PL202100191

CLOVER MALL
BLOOMINGTON, MN

20 JULY 2021

1

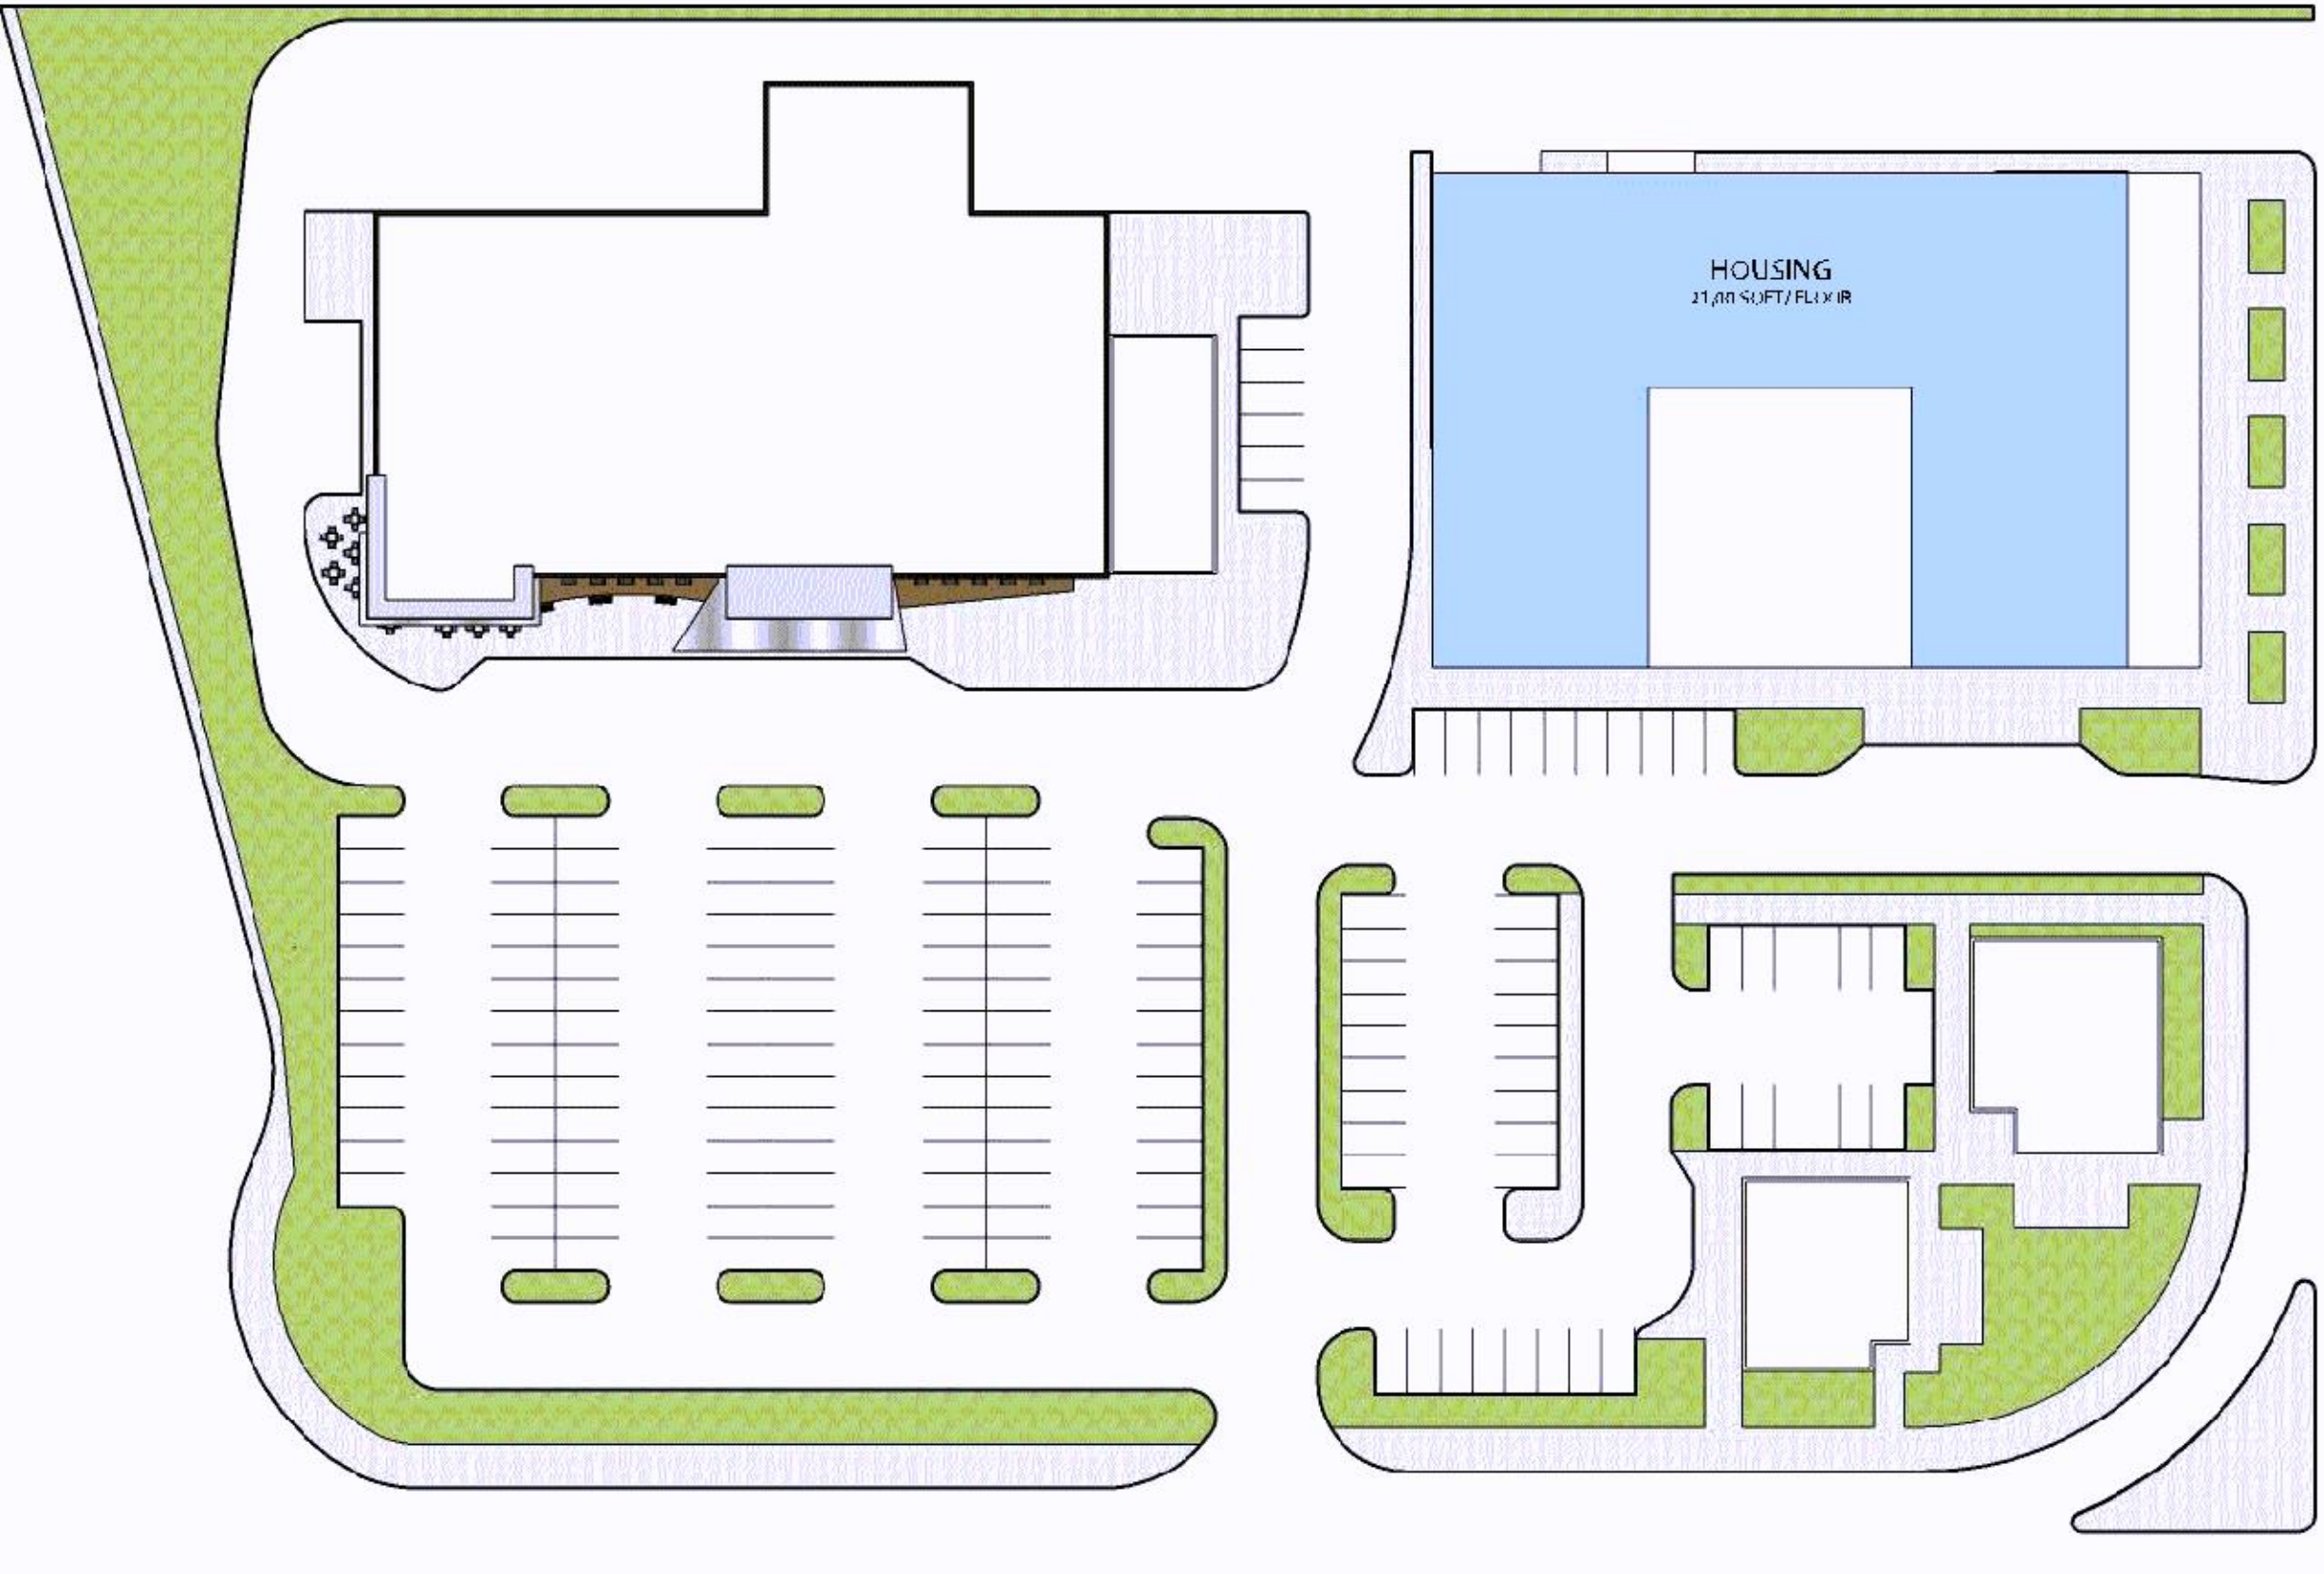
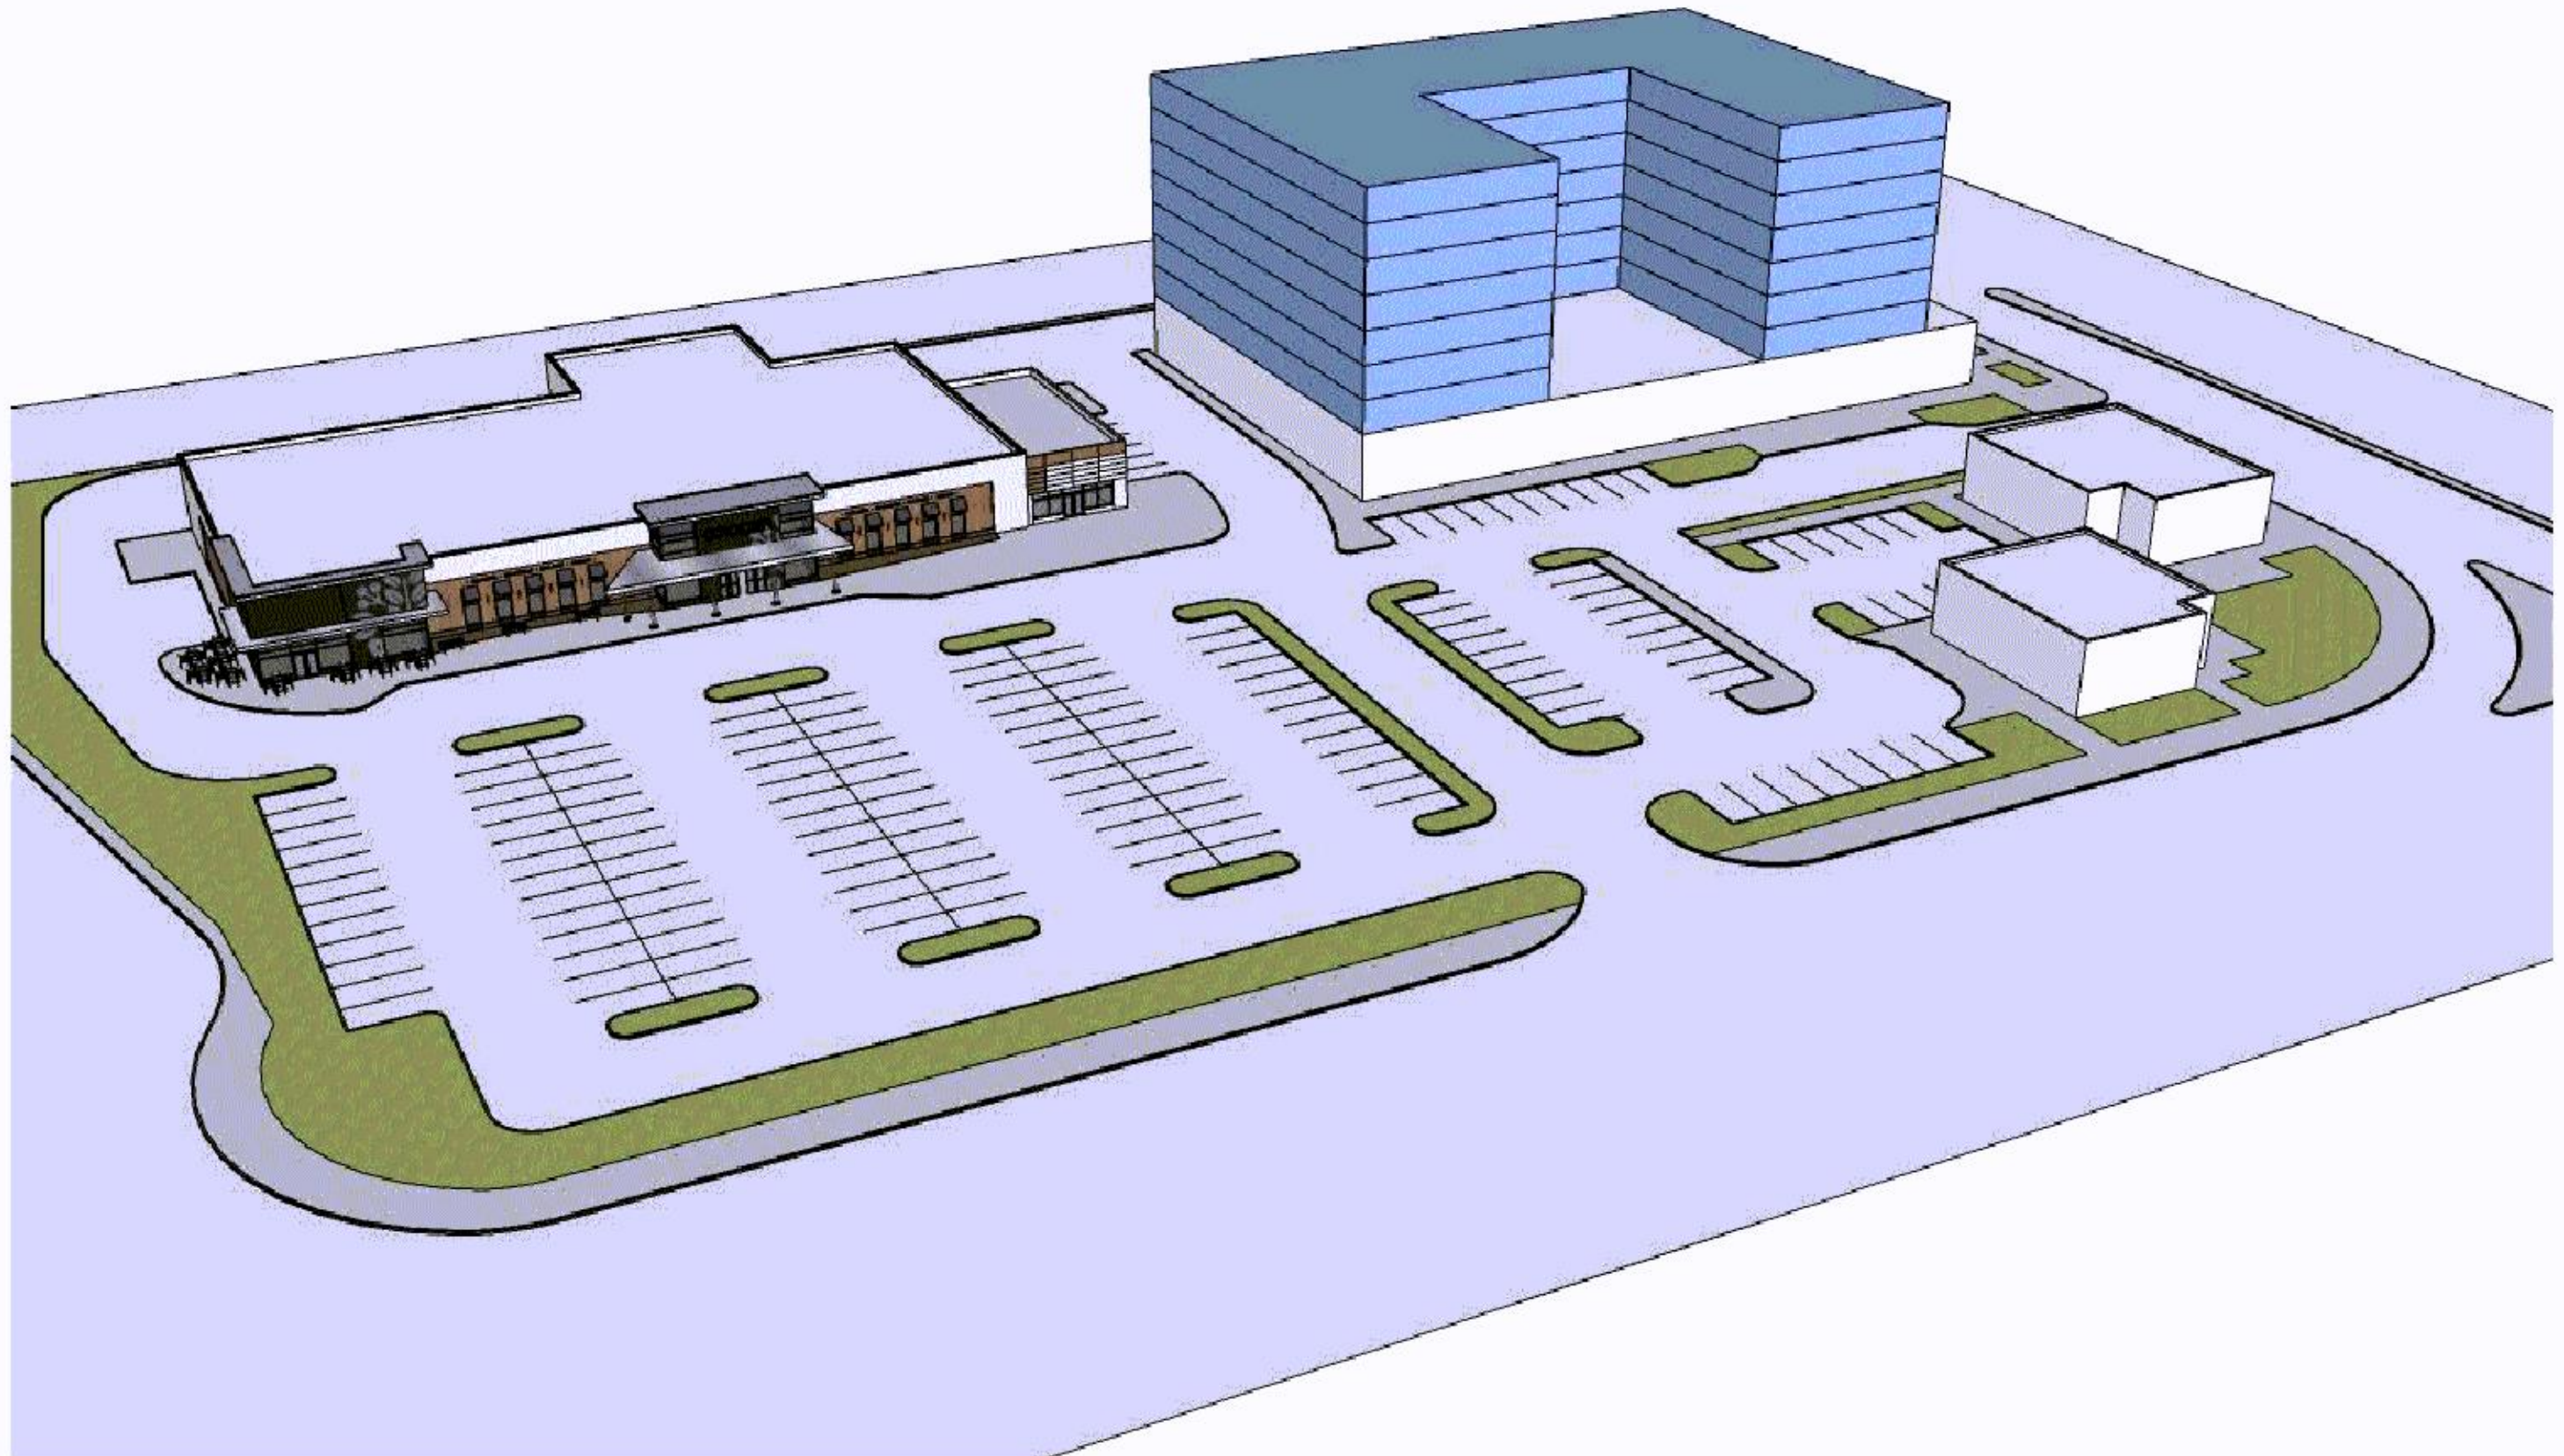
Revise sheet 1 of the
preliminary development plan
so the grocery building
footprint, parking lot design,
and pedestrian connection for
the grocery are consistent with
civil plans.

The square footages
in the preliminary
development plan are
inconsistent with the
rest of the plan set.
Amend accordingly

Neither of the future retail
buildings in the southeast
corner of the site meet the
minimum 4,000 square foot
size requirement. Adjust the
building size to 4,000 square
feet. Alternatively, request a
deviation for the future
phase and detail how the
corner and the two buildings
could be designed to have a
unified street presence.

Please adjust this page in the preliminary development plan. There are some minor inconsistencies.
